# HAL300 Differential Hall Effect Sensor IC

<b>Subject:</b>	Improvement of SOT-89B Package
<b>Data Sheet Concerned:</b>	HAL 300, 6251-345-1DS, Edition July 15, 1998 HAL 320, 6251-439-1DS, Edition July 15, 1998
<b>Supplement:</b>	No. 1/ 6251-532-1DSS
<b>Edition:</b>	July 4, 2000

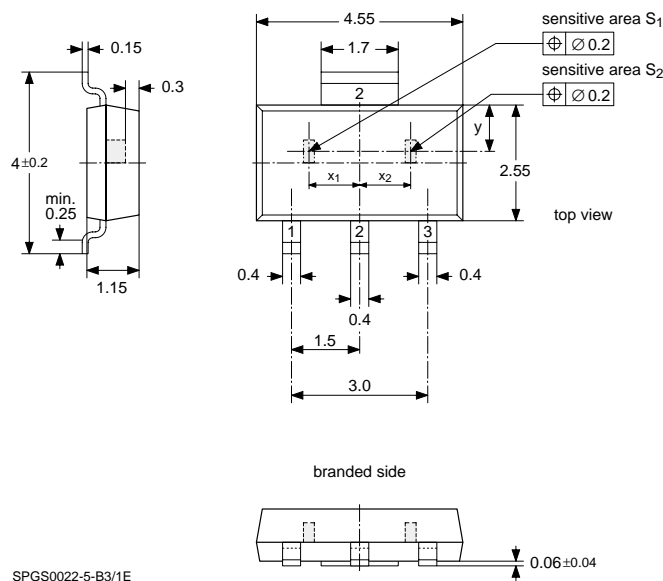
**Changes:**

- position tolerance of the sensitive area reduced
- tolerances of the outline dimensions reduced
- thickness of the leadframe changed to 0.15 mm (old 0.125 mm)
- HAL 300 now available in SOT-89B
- SOT-89A will be discontinued in December 2000

**Position of sensitive area**

HAL 300	HAL 320
x <sub>1</sub> +x <sub>2</sub>	(2.05±0.001) mm	(2.25±0.001) mm
x <sub>1</sub> = x <sub>2</sub>	1.025 mm nominal	1.125 mm nominal
y	0.95 mm nominal	0.95 mm nominal

**Note:** A mechanical tolerance of ±0.05 mm applies to all dimensions where no tolerance is explicitly given. Position tolerances of the sensitive areas are defined in the package diagram.
